SUBJECT: ISSUANCE OF AMENDMENT NO. 106 TO FACILITY OPERATING LICENSE NO. NPF-2 REGARDING INTERIM PLUGGING CRITERIA OF THE STEAM GENERATOR TUBE DEFECTS WITHIN THE BOUNDARY OF THE SUPPORT PLATE - JOSEPH M. FARLEY NUCLEAR PLANT, UNIT 1 (TAC NO. M88375)

SUBJECT: ISSUANCE OF AMENDMENT NO. 106 TO FACILITY OPERATING LICENSE NO. NPF-2 REGARDING INTERIM PLUGGING CRITERIA OF THE STEAM GENERATOR TUBE DEFECTS WITHIN THE BOUNDARY OF THE SUPPORT PLATE - JOSEPH M. FARLEY NUCLEAR PLANT, UNIT 1 (TAC NO. M88375)

AMENDMENT TO FACILITY OPERATING LICENSE

SAFETY EVALUATION BY THE OFFICE OF NUCLEAR REACTOR REGULATION
RELATED TO AMENDMENT NO. 106 TO FACILITY OPERATING LICENSE NO. NPF-2
SOUTHERN NUCLEAR OPERATING COMPANY, INC.
JOSEPH M. FARLEY NUCLEAR PLANT, UNIT 1
DOCKET NO. 50-348

FIGURE 3-4-1

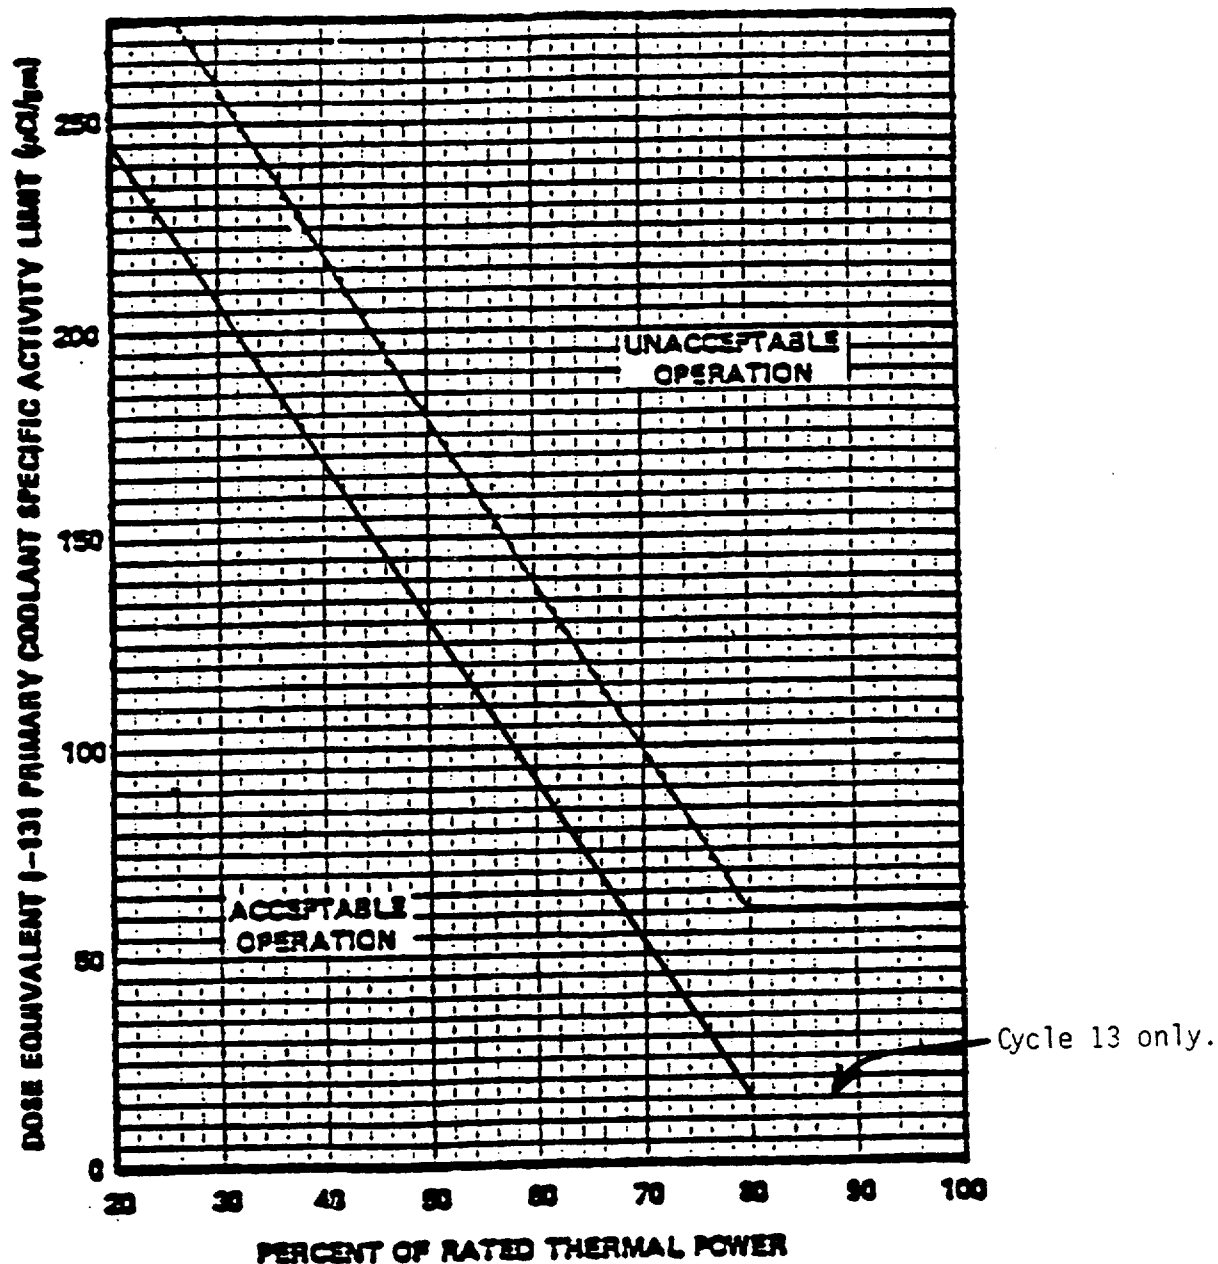
- a. Less than or equal to 0.25 microCurie per gram DOSE EQUIVALENT I-131 for the Thirteenth Operating Cycle only;
- b. Less than or equal to 1.0 microCurie per gram DOSE EQUIVALENT I-131 for subsequent cycles;
- c. Less than or equal to $100/\bar{E}$ microCurie per gram.

(Activity $> .25 \mu\text{Ci/gram}$ Dose Equivalent I-131 for Cycle 13 only.)
